**PLANNING COMMISISON
SITE PLAN
CONDITIONAL USE PERMIT REVIEW SHEET**

CASE NUMBER: SPC-2018-0253CX **PC DATE:** November 27, 2018

PROJECT NAME: Govalle Elementary School

CITY OF AUSTIN – DEVELOPMENT SERVICES DEPARTMENT
SITE PLAN APPLICATION – MASTER COMMENT REPORT

100% ISSUE FOR PROPOSAL
TEMPORARY QUEUING COMPLETED PHASE I
AP02

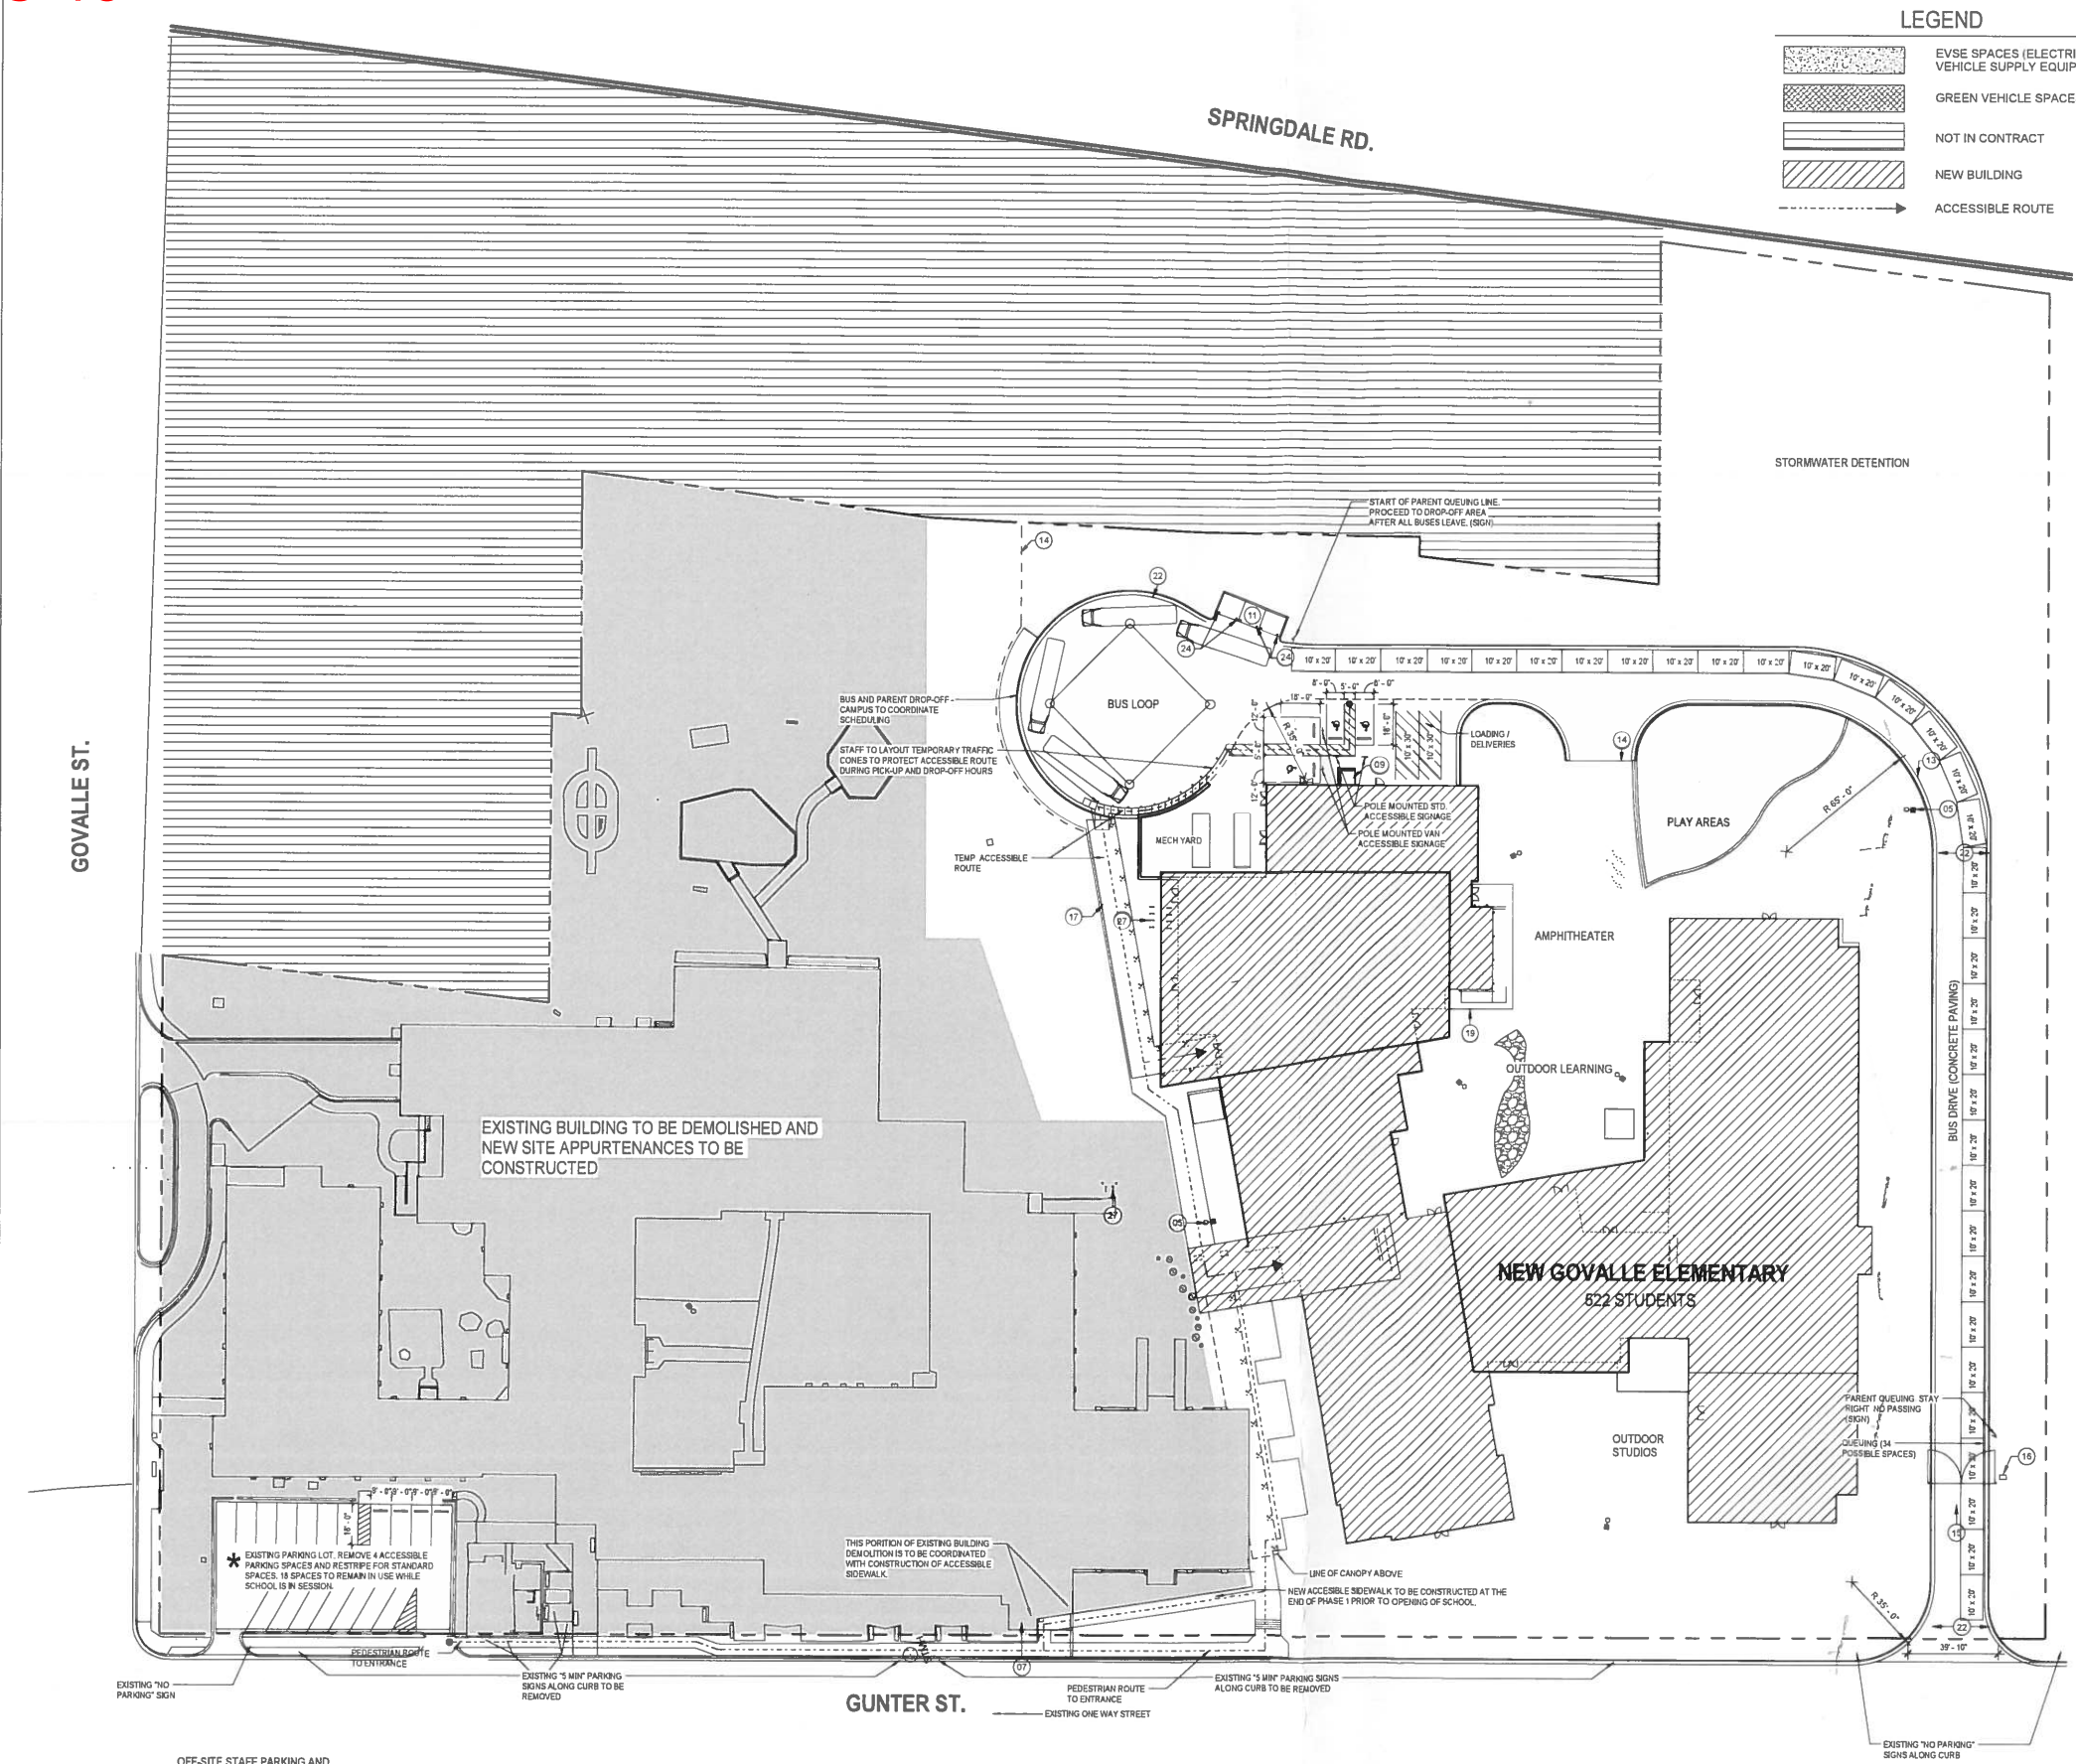
- f. **Show the pedestrian route from the 18 parking spaces for Phase II to the building entrance. It is unclear how individuals will access the building entrance due to the construction.**

- d. *Show the pedestrian route in Phase II from the 18 spaces to the building entrance. It is unclear how pedestrians will get to the building from the parking through the construction*

RESPONSE_ *Pedestrian route has been indicated on sheet AP02.*
